APPLICATION NO. 051A 00728	PROJECT NO. 1002505
PROJECT NAME Villa De La Capilla	
EPC APPLICATION NO.	
APPLICANT / AGENT William D. Wieser	PHONE NO. 306-1002
ZONE ATLAS PAGE F-13	
(SDP for SUB), (SDP for BP), (FINAL PLATS), (MASTER DEV PLAN), (IR) (AA)

ADMINISTRATIVE AMENDMENT

File # 05-00728 Project # 1002565

Front setback adjustment.

SITEPLAN

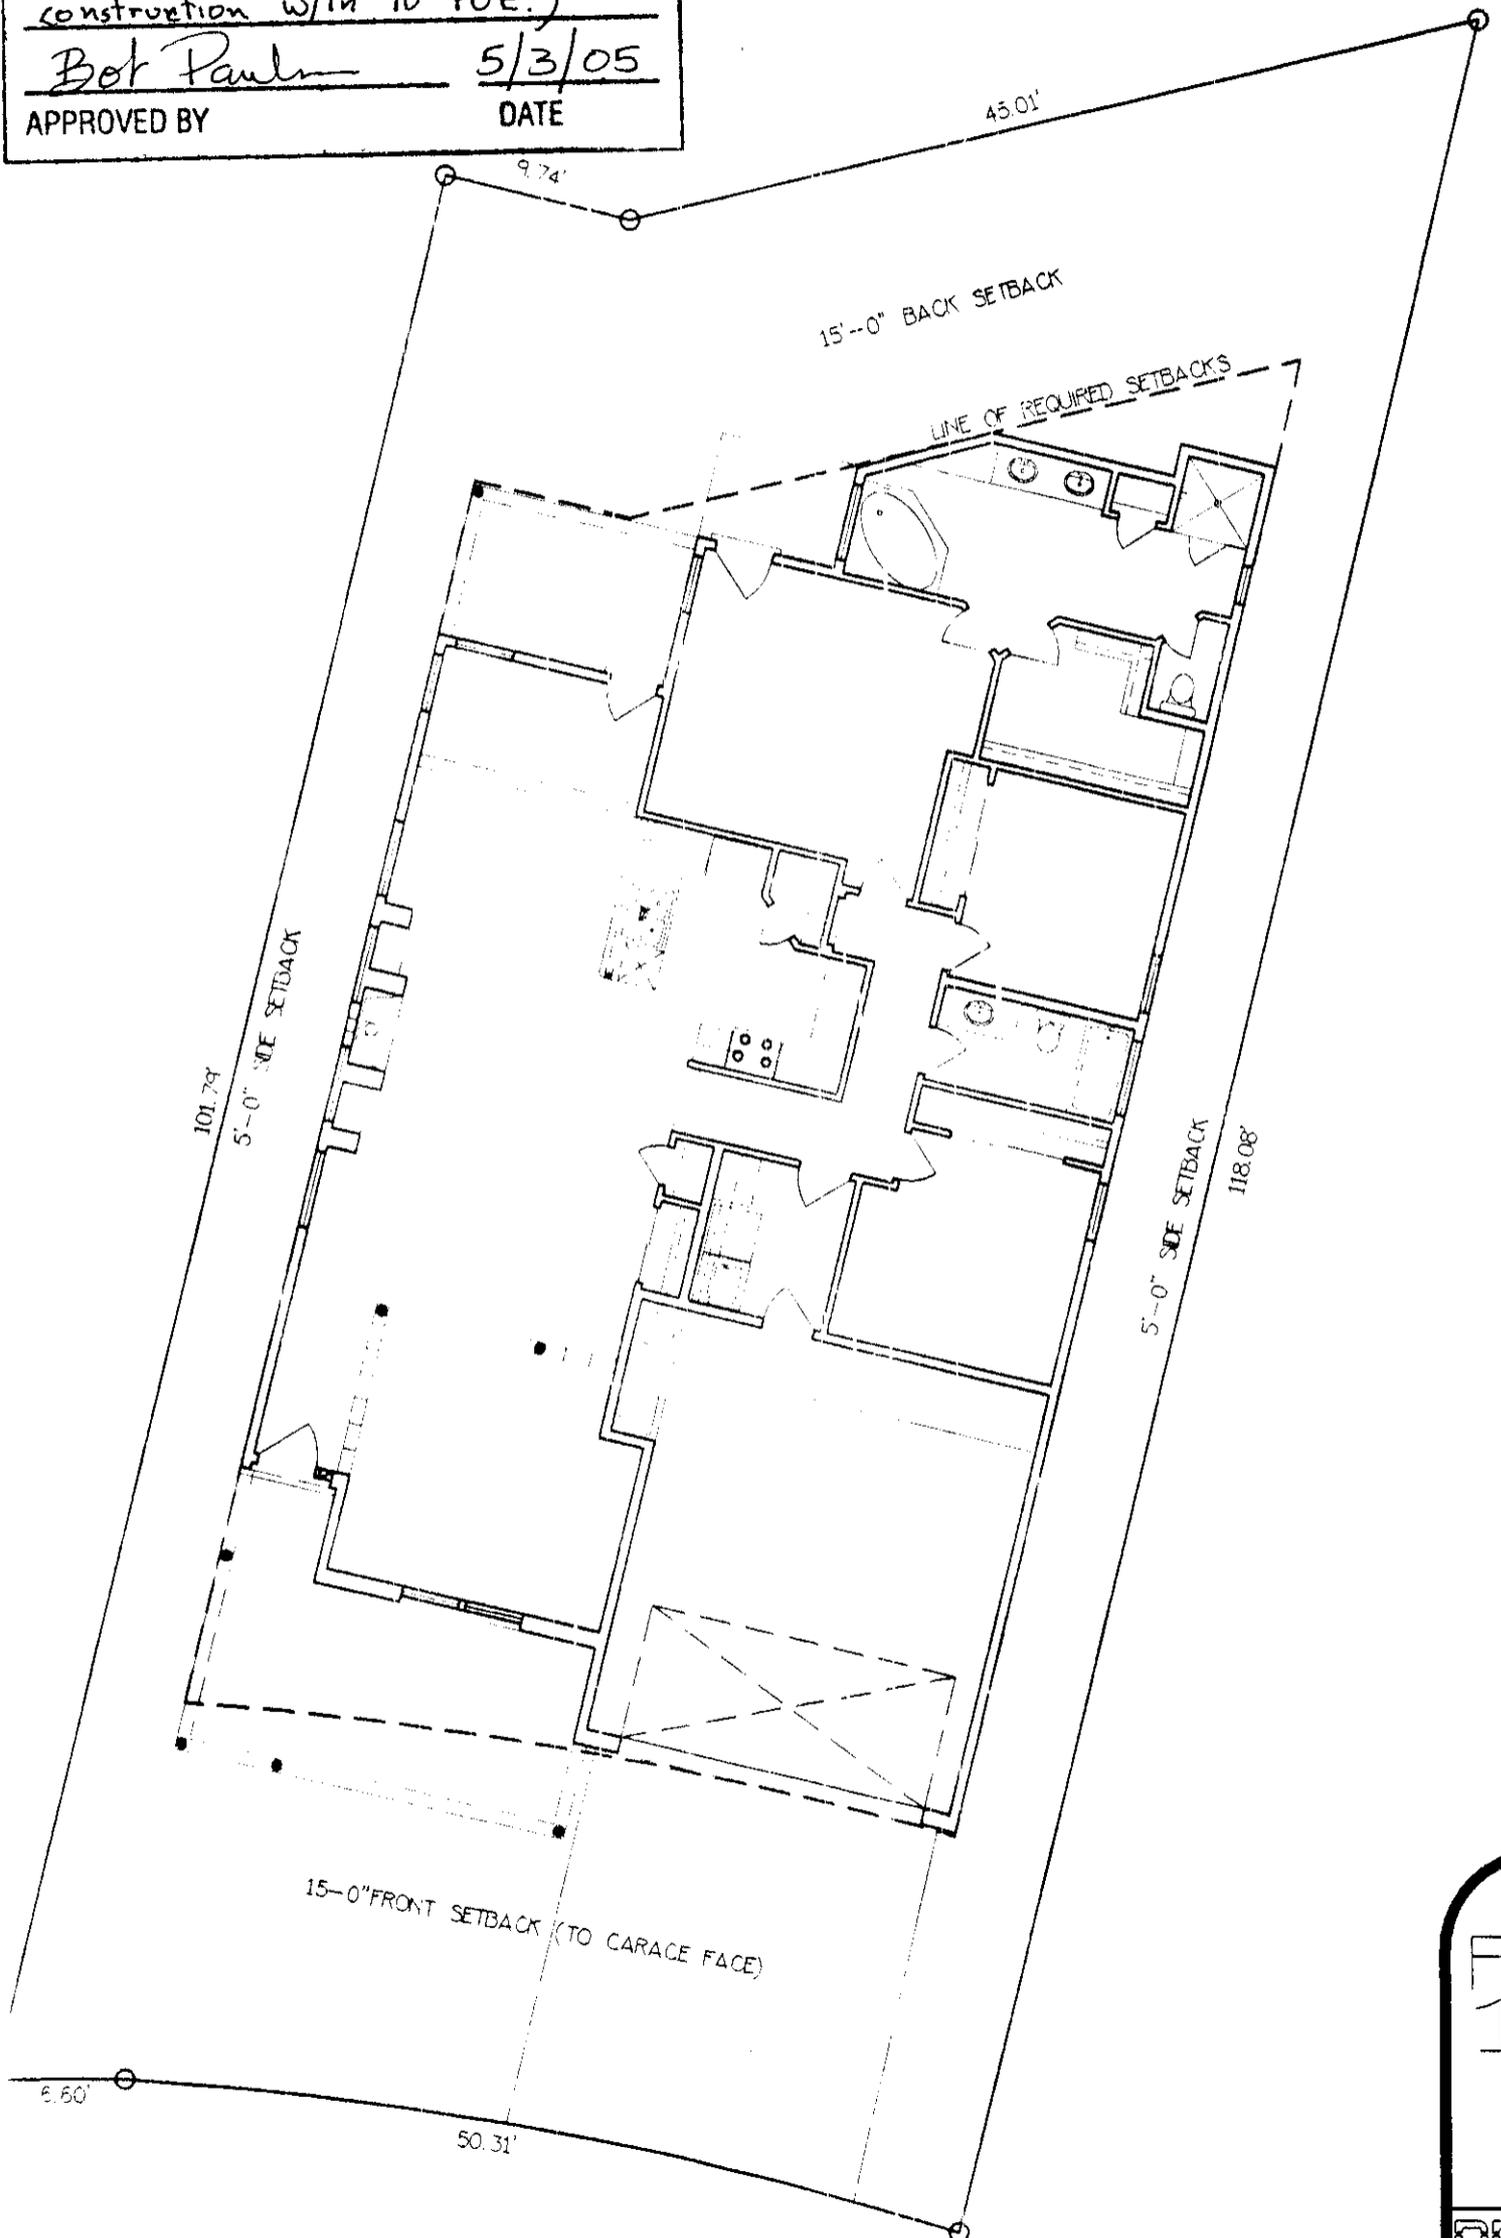
(This approval does not authorize construction w/in 10' PUE.)

IMPROVEMENT LOCATION SKETCH

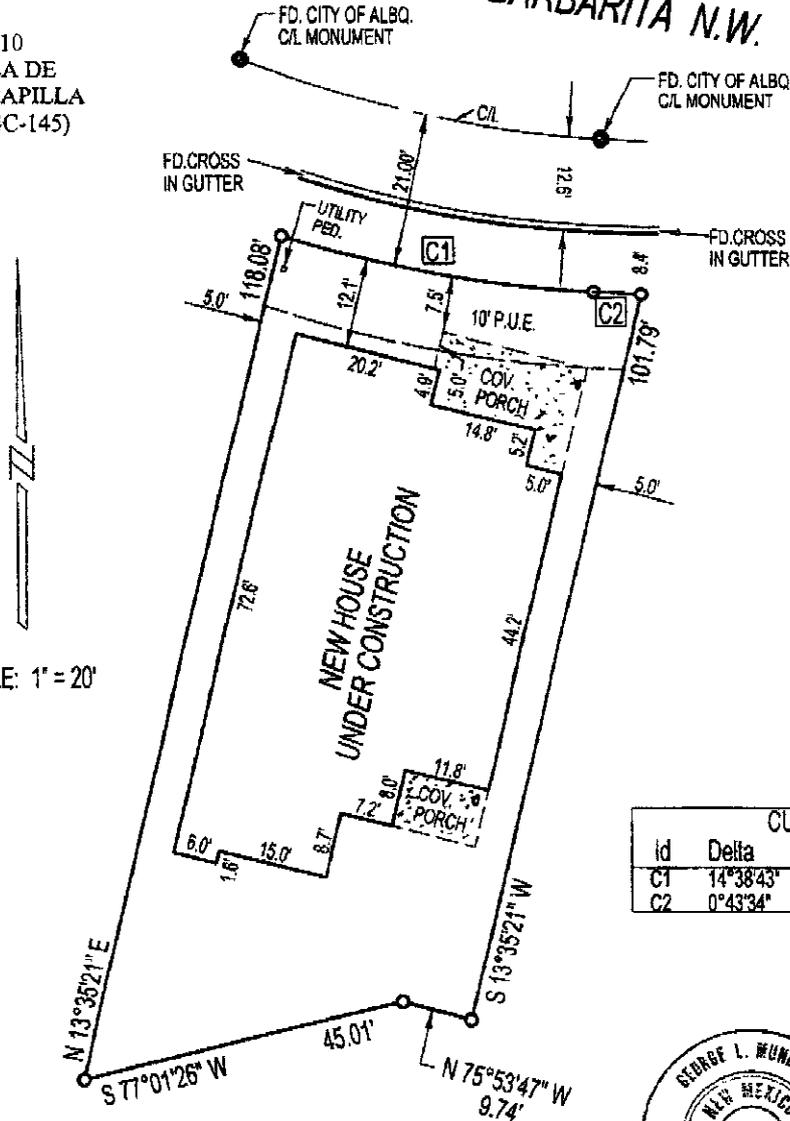
There are two reasons for placing the home where it is located.

1. In the layout per the original plat I discovered that the location shown on plot plan placed my home 8' back from the home located on Lot 11. This location would have made the home look very much out of place.
2. Remembering that the plat filed with the city in the "Notes" portion item 2 labeled Building Setbacks, state:
Front: 10'
Rear: 15'
Side: None, provided 10' exists between buildings
Driveway: 20' from garage to street

It made since at the time that the drawn location was incorrect and that I should move the home forward to the 20' from garage to street.

SITEPLAN
SCALE: 1"=10'-0"

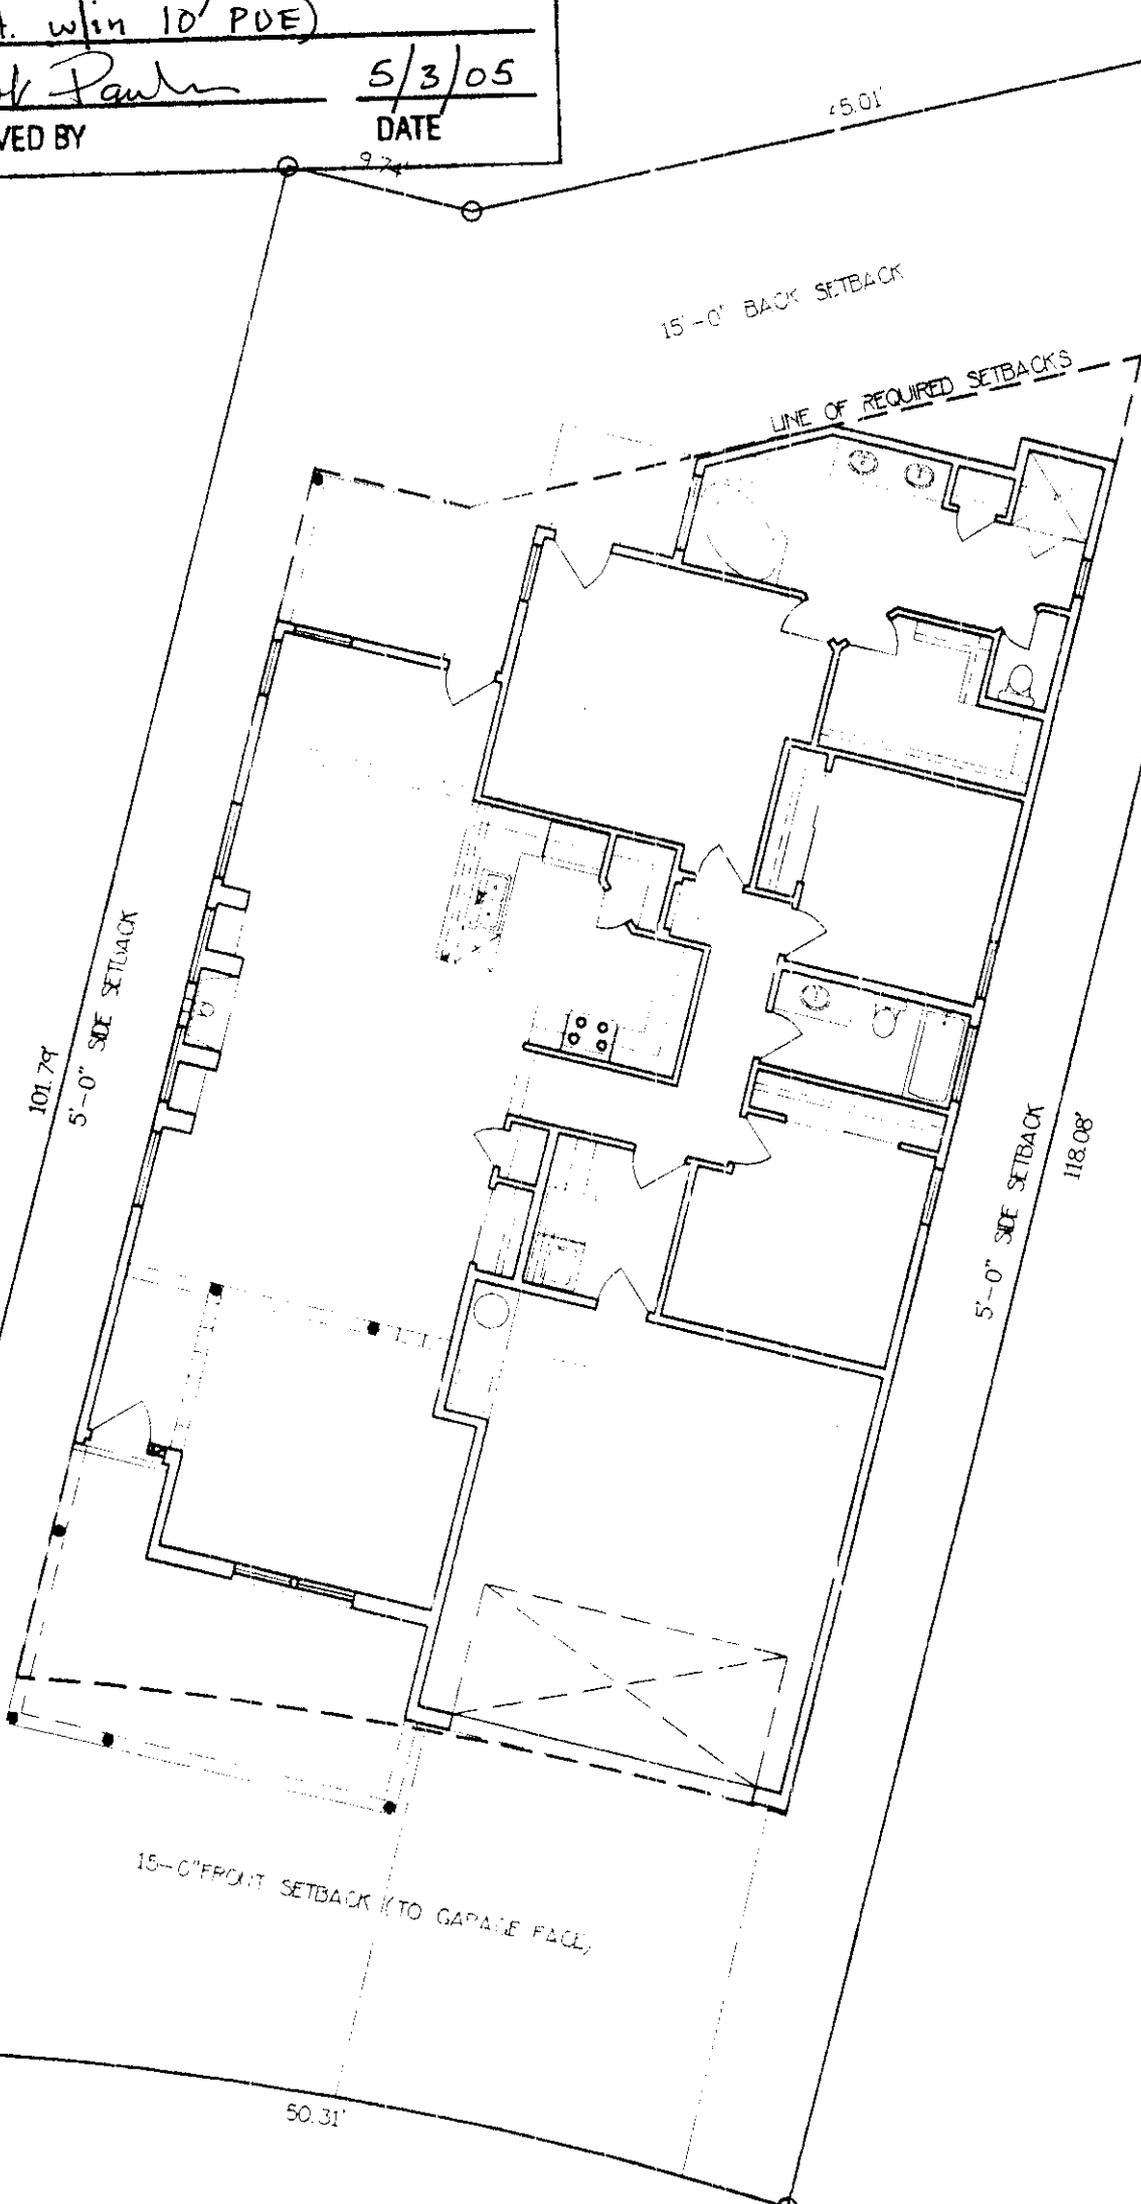
Front setback adjustment.

(this approval does not authorize const. w/in 10' PDE)
